SERVICE No. 1008 BULLETIN

Elevator Butt Rib Refinement

PA-31, 31-300, 31-325 Navajo
PA-31-350 Navajo Chieftain
PA-31-350 T1020
PA-31P-350 Mojave

Approximate location of doubler plate on left and right elevators. Installation of doubler plate indicates the installation of the Elevator Butt Rib Refinement Kit p/n 766-642.

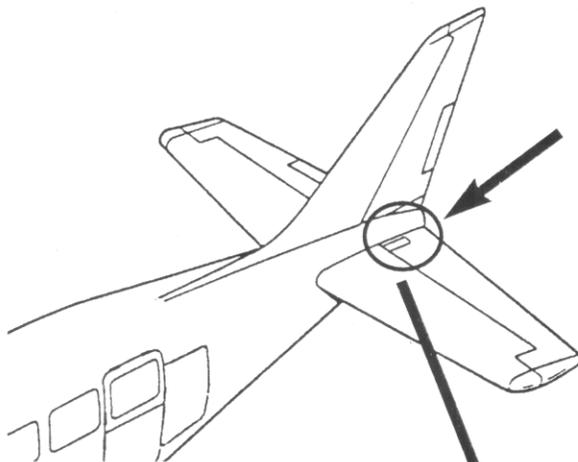
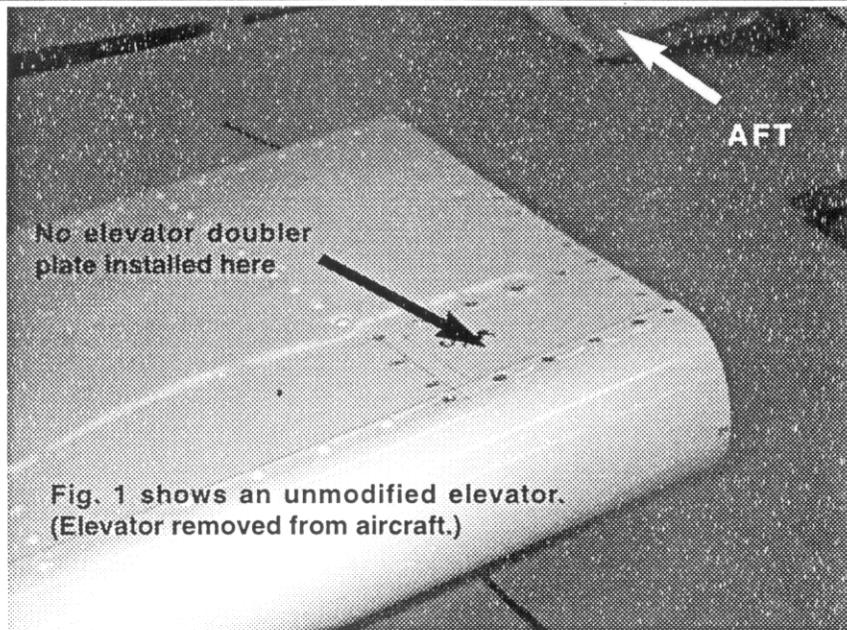
1. Check the aircraft for previous compliance with Service Bulletin 998 or 998A. If compliance was achieved by the installation of the prescribed new elevator assembly, refer to instruction 2. If compliance was achieved by the installation of a new elevator spar, refer to instruction 3.
2. Inspect the left and right elevators per the figures shown on page 3. If a doubler appears on the top inboard end of the elevator, compliance with this Service Bulletin has been achieved. Proceed to instruction 4. If no doubler appears, even if a new elevator has been installed per Service Bulletin 998 or 998A, continue with these instructions.

3. Install the Elevator Butt Rib Refinement Kit (1 per aircraft), Piper Part Number 766-642. All of the necessary instructions for installation are contained in the Elevator Butt Rib Refinement Kit.
4. Make an appropriate logbook entry of compliance with this Service Bulletin.
